DRC-2021-004704

MEMORANDUM

SUBJECT: Review of the Energy Fuels Resources (USA) Inc. (EFR), White Mesa Uranium Mill, Blanding, Utah October 19, 2020 Source Assessment Report for Selenium and Uranium in Monitoring Well MW-28  
Ground Water Discharge Permit No. UGW370004 (Permit)

Selenium Data Plot of Historical Data at MW-28

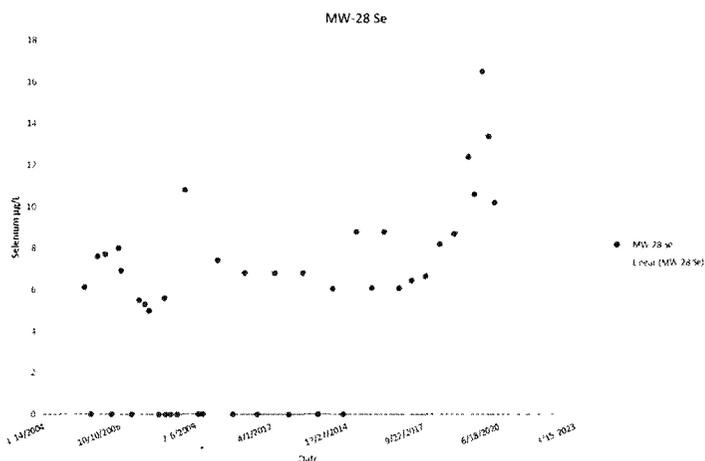
Both data sets show an inflection (rising trend) beginning post 2017.

**Selenium** – The SAR notes that selenium concentrations in MW-28 are relatively low for the site. The time series plots show variability in selenium concentrations prior to 2012 and an increase in concentrations following the 2014 damage and repair. A point of inflection is apparent showing an increasing trend post 2017. The SAR discusses that this trend is likely associated with the mobilization of naturally occurring selenium in the formation by nitrate from the nitrate/chloride plume, oxidation of selenium-bearing pyrite by nitrate, and generally elevated selenium concentrations within the nitrate/chloride plume.

Uranium Data Plot of Historical Data at MW-28

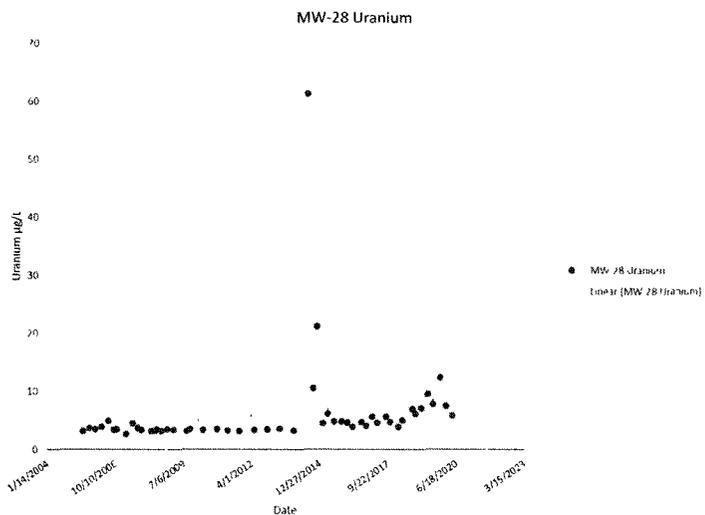
**Uranium** – The SAR notes that uranium concentrations in MW-28 are relatively low for the site. A spike in concentrations is noted in 2014 associated with the well damage and repair. There is a point of inflection apparent in the post 2017 data where an increasing trend is evident. The SAR discusses that this trend is likely due to mobilization of naturally occurring uranium in the formation by nitrate in the nitrate/chloride plume, increased mobility of naturally occurring uranium resulting from increased bicarbonate.

Figure – Chloride Plot of Historical Data at MW-28 – Increasing Trend

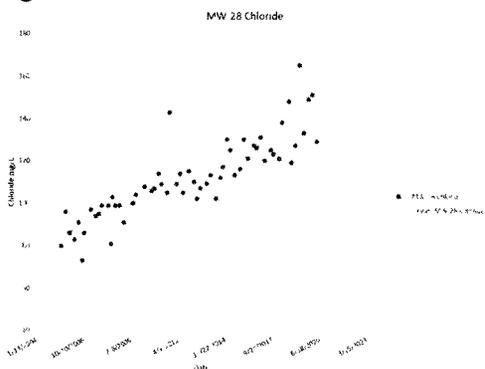
The use of chloride as an indicator parameter in the case of monitoring well MW-28 is complicated by the fact that MW-28 appears to be impacted by the nitrate/chloride plume, and chloride is therefore increasing and is not a reliable primary indicator of cell leakage for MW-28. Chloride at monitoring well MW-28 is now showing a significant increasing trend.

Figure – Fluoride Plot of Historical Data at MW-28 – Decreasing Trend

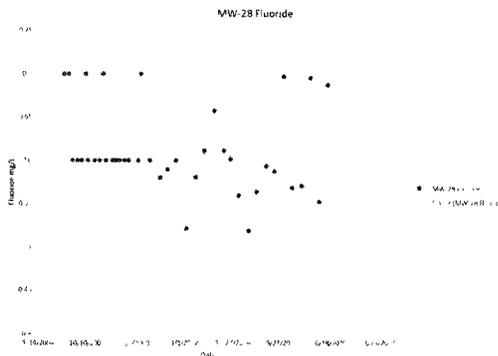
Fluoride concentrations were decreasing at the time of the Background Report and continue to show a decreasing trend.

Figure – Sulfate Plot of Historical Data at MW-28 – Decreasing Trend

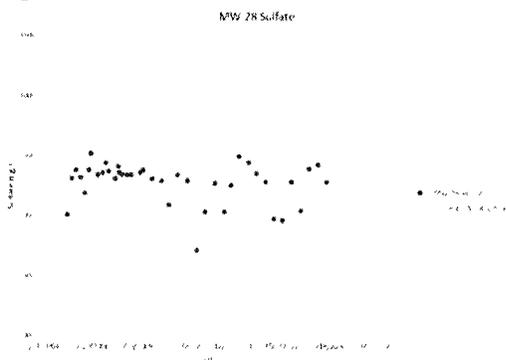
Sulfate concentrations in MW-28 exhibit a slight decreasing trend.
